Determination 2016/023

Regarding a building consent application and the compliance of the proposed bracing system for a single-storey building at 15/17 Rankin Street, Stewart Island

Figure 1: Elevation indicating brace frame (Not to scale)

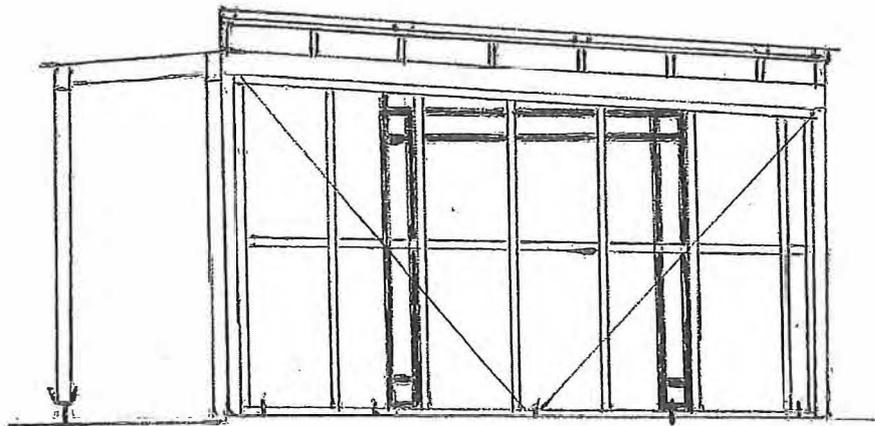
- 2.4 The applicant confirmed that the 40mm SHS (square hollow section) brace frame would be checked into the timber framing, with M12 bolts into the top and bottom plates at 300mm centres. The brace frame is to be welded with 7018 shipping grade welding rods, and no treatment of the weld affected zones is proposed because the brace frames will be fully enclosed. The galvanised anchors are located at the corners into the concrete. There would be two brace-frames (pairs) in each external wall, with the maximum sized brace frames being 2.3 x 2.3m.

- The design of these frames are limited by their deflection. A sway frame (which is what you want) has to move a lot more to bring the load to the ground. As a result you need a larger frame in the order to get the load to ground. This also has a high pull and push force (tension and compression forces) with this type of system. This results in a bigger foundation which you have not allowed for.

- For wind you need 7.5kN for a building of this size in a high wind zone, which relates to 150BU.
- Nothing has been sent to [the authority] as we have just shown your 25SHS brace does not work for the applied wind loading as it is too flexible.

- 6.1.3 The testing on the brace undertaken by the applicant indicated a deflection of 50mm at a maximum applied load of 6.76kN. A theoretical calculation for deflection at this load is 65mm. The reason for this difference is not clear, but is not considered materially relevant to this determination.

- 6.1.4 Of more direct relevance is consideration of how this order of deflection or deformation translates to compliance with the Building Code. A deformation of, say, 60mm at the design wind loading of 7.5kN would cause significant damage to the structure. For comparison, buildings designed using NZS 3604 would be considered to have a serviceability deformation limit of approximately 8mm per 2.4m height.

- 6.1.5 A structure using the tested bracing frame would deflect to the extent it would be considered to have become unserviceable when the wind speed reaches only 38% of the expected maximum design wind speed. Such wind speeds could reasonably be expected to occur frequently (from annually to 10-yearly).

6.2.5 I consider the documentation is inadequate, in that it lacks supporting calculations that demonstrate the building has sufficient capacity and stiffness to resist design loads (earthquake and wind) as required by the Building Code. The design differs from NZS 3604 in that bracing is provided by the brace frames which are not included in NZS 3604. The structural design is therefore a specific design, and the producer statement from the applicant does not provide an adequate engineering basis to support the design.

- 7.1 In accordance with section 188 of the Building Act 2004, I hereby determine that with regard to the proposed method of bracing the authority correctly exercised its powers in respect of the building consent application, and I confirm the authority's decision in this respect.
